# APPLICATION STATEMENT

## NON-MATERIAL CHANGE APPLICATION

### HINKLEY POINT C DEVELOPMENT CONSENT ORDER

<b>Revision</b>	01
<b>Date of Issue</b>	July 2020
<b>Status</b>	S2 - FIT FOR INFORMATION
<b>Owner &amp; Approver</b>	Andrew Goodchild
<b>Technical Reviewer</b>	Jonathan Legg
<b>Author</b>	John Pingstone

## APPENDIX 1 SITE LAYOUT PLAN

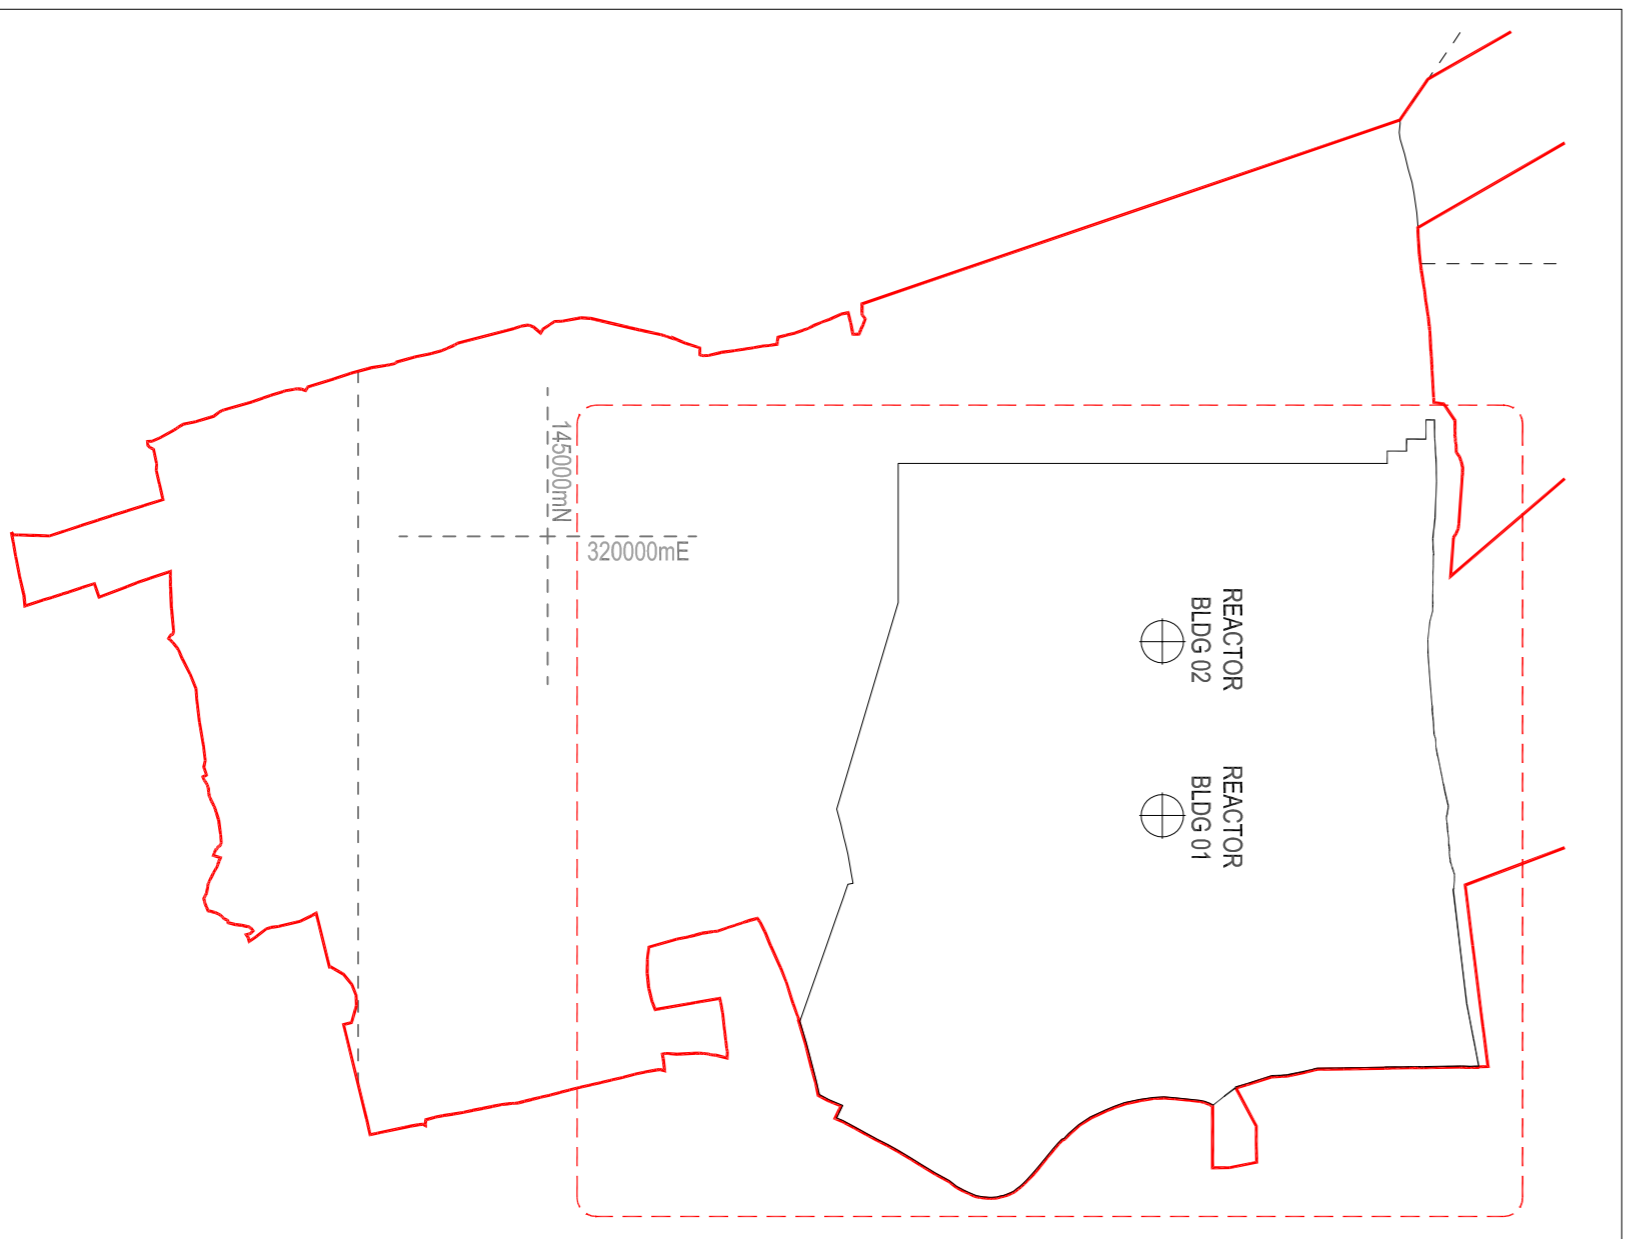
- 2.4.7 EDF is now proposing to move the location and function of this building on the proposed Site Layout Plan (**Appendix 1**) so that it would be co-located with the other emergency response buildings. In addition, the new location would have the benefit of avoiding the building being located on the rock strata known as the Blue Anchor Formation, which does not provide the highest seismic qualification level which is needed for a safety classified building.

- 2.4.9 As indicated on the proposed Site Layout Plan (**Appendix 1**), the footprint occupied on the previously approved Site Layout Plan<sup>3</sup> by the Emergency Response Store would instead be occupied by the Oil & Grease Storage & Oil Ancillary Building.

- 2.4.14 As shown on the proposed Site Layout Plan, the functions of Oil and Grease Storage and Oil Ancillary Building would move to the footprint occupied by the Emergency Response Store on the previously approved Site Layout Plan <sup>5</sup>.

2.4.31 EDF is proposing to add the Emergency Response Centre to the Site Layout Plan. This building provides additional capacity and functionality to enhance the existing approved emergency facilities. No building was located at this location on the previously approved Site Layout Plan<sup>3</sup>.

2.4.39 EDF is proposing to remove the Entry Relay Building from the Site Layout Plan.

- 2.4.50 EDF is proposing to increase the dimensions and footprint of the Filtering Debris Recovery Pit, for both Units 1 and 2. The location of each Filtering Debris Recovery Pit is otherwise unchanged, as shown on the proposed Site Layout Plan.

2.4.54 EDF is proposing to remove the Helipad which was included in the previously approved Site Layout Plan<sup>3</sup>.

- 2.4.60 EDF is proposing to increase the footprint of the Sewage Treatment Plant in order to accommodate all of the equipment which has been identified to ensure the necessary quantities of waste water is treated appropriately. The location of the Sewage Treatment Plant remains consistent with the previously approved Site Layout Plan. The DCO approved design was a wireframe outline, as at the time of the DCO application the precise quantity and type of waste water and the design of the required treatment facilities had not been finalised.

**Figure 1**  
**Building Change Location Plan**

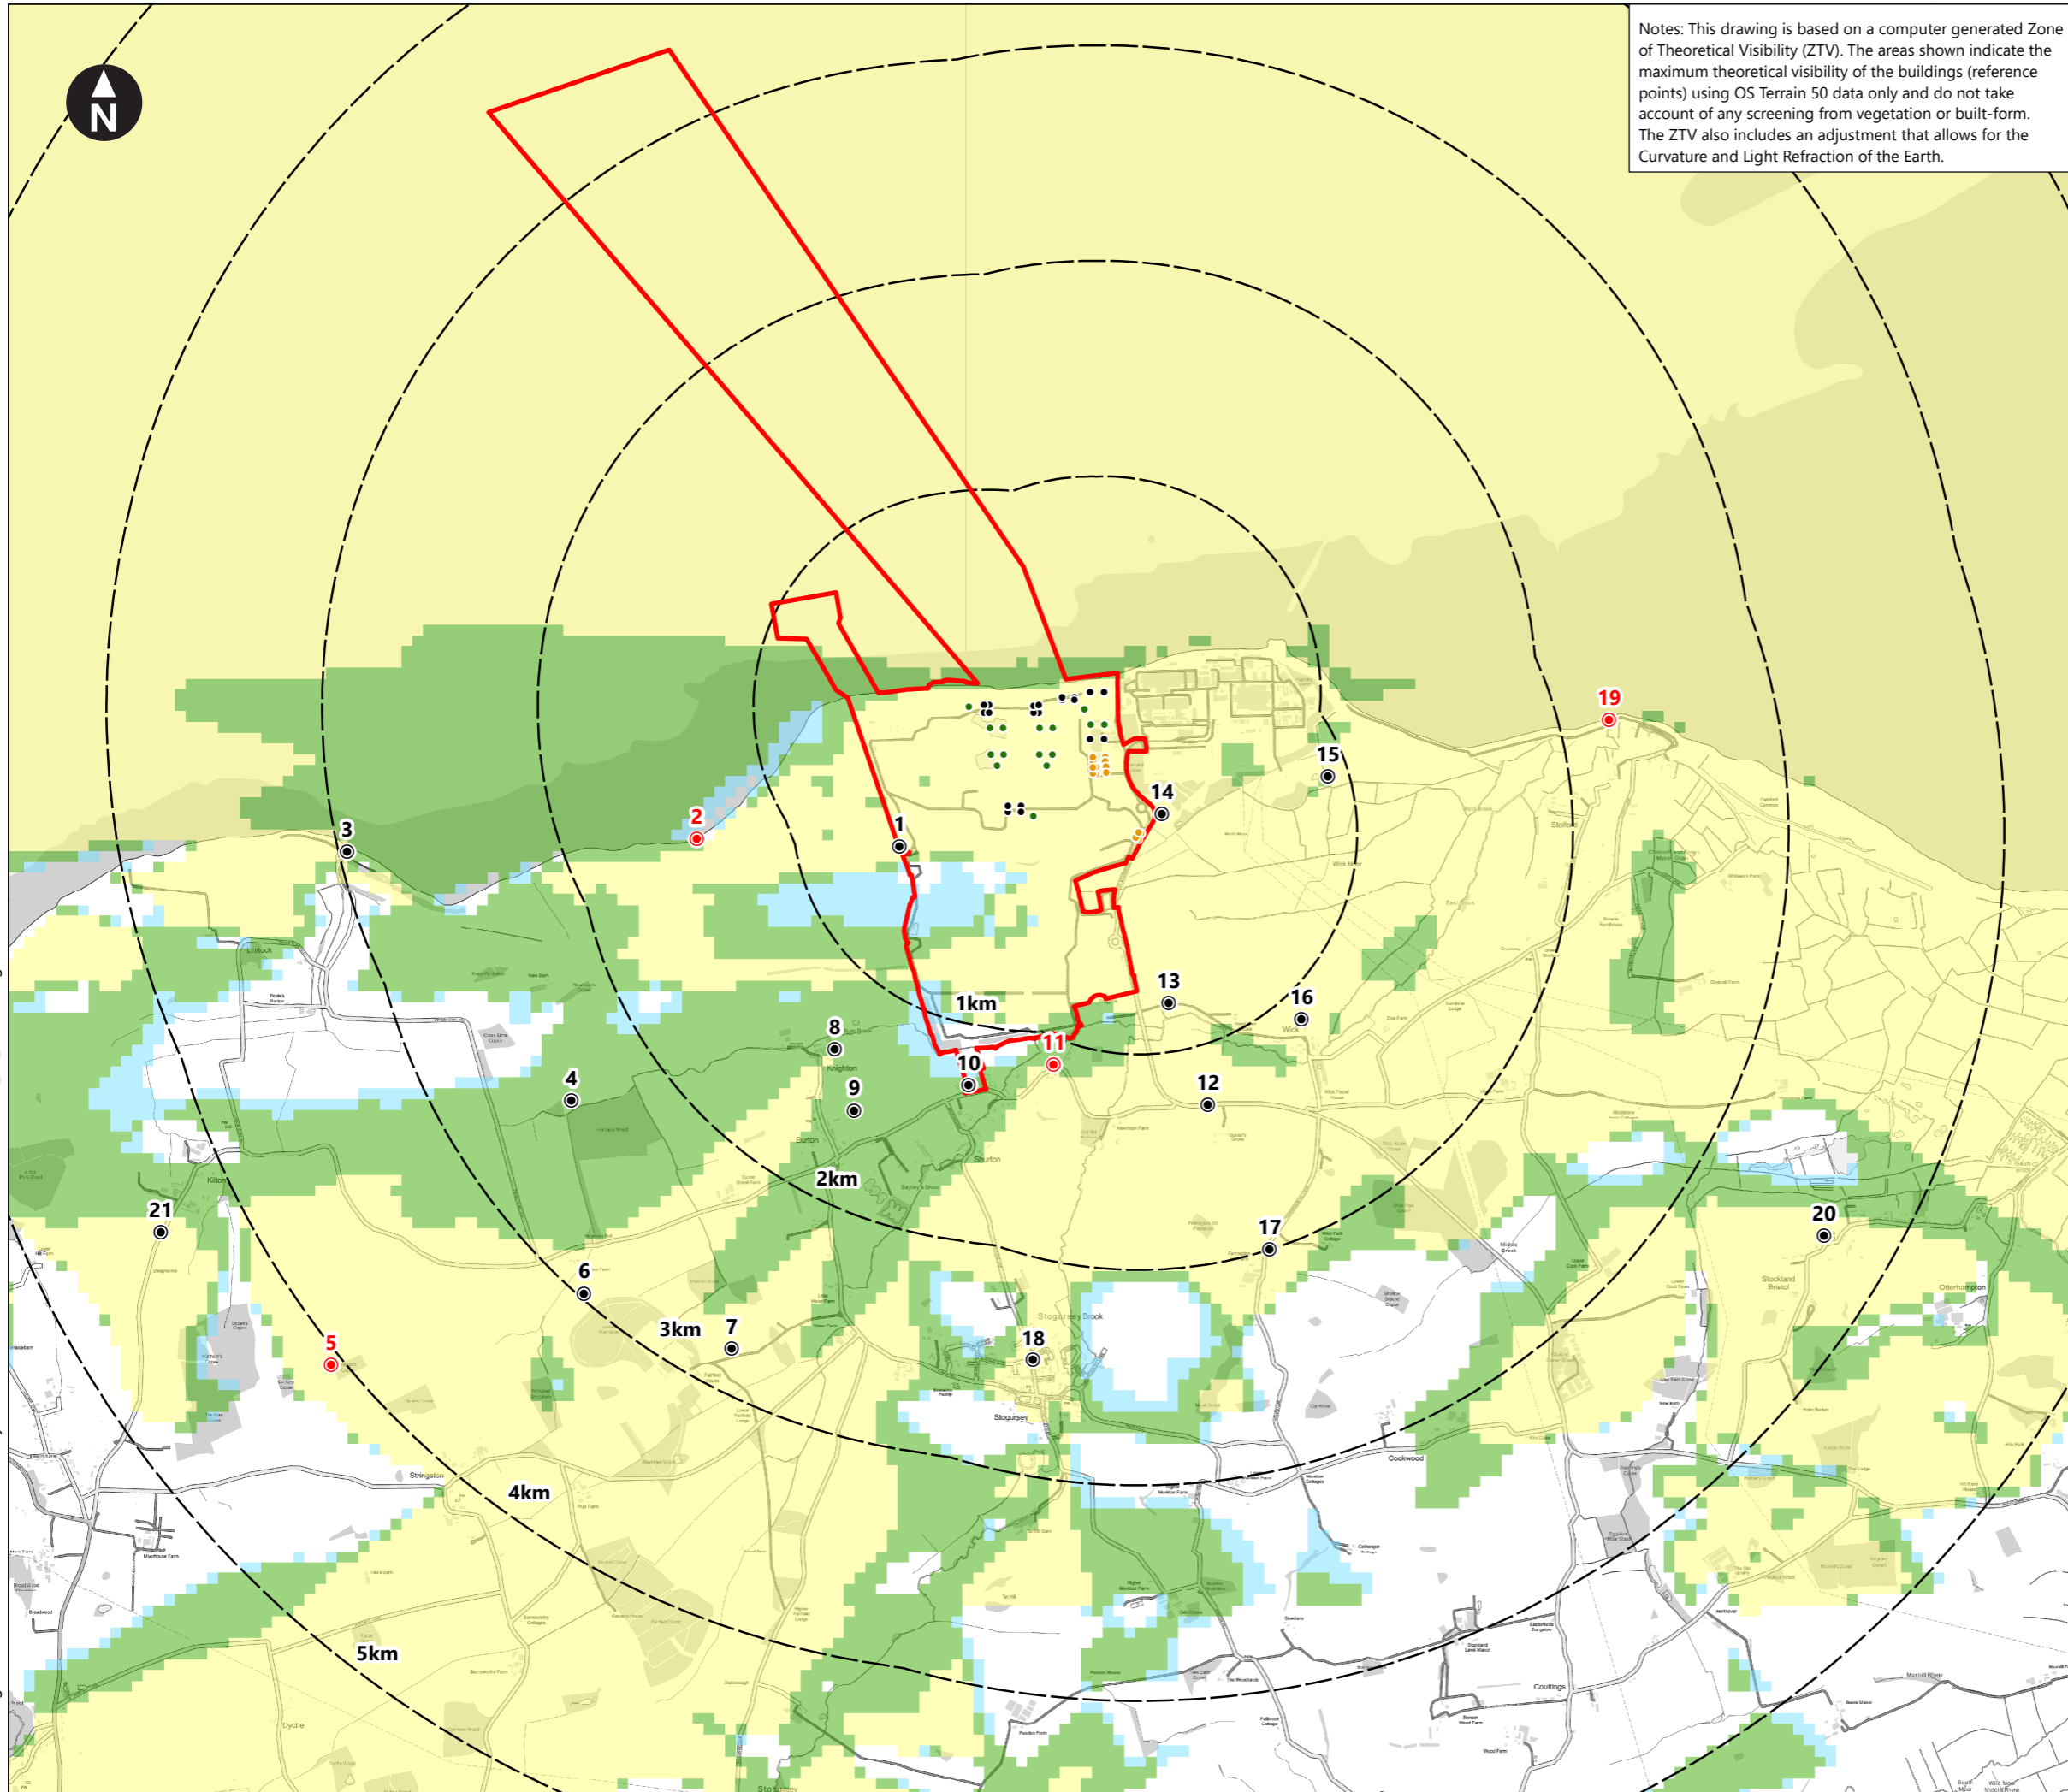
HPC have reviewed the need, design, function and arrangement of permanent buildings and structures which would be part of the operational power station. This has resulted in changes to size, name and location of buildings on the Site Layout Plan, including the removal and addition of buildings and structures. The proposed changes are shown in 'Site Layout Plan (Operational) Regulation 5(2)(o)' (HINK-A1-SL-00-GA-010 Rev 04) at Appendix 1. A simplified layout of the proposals is illustrated in **Figure 1**. The proposed revisions to the consented layout will be a permanent change to the operational layout.
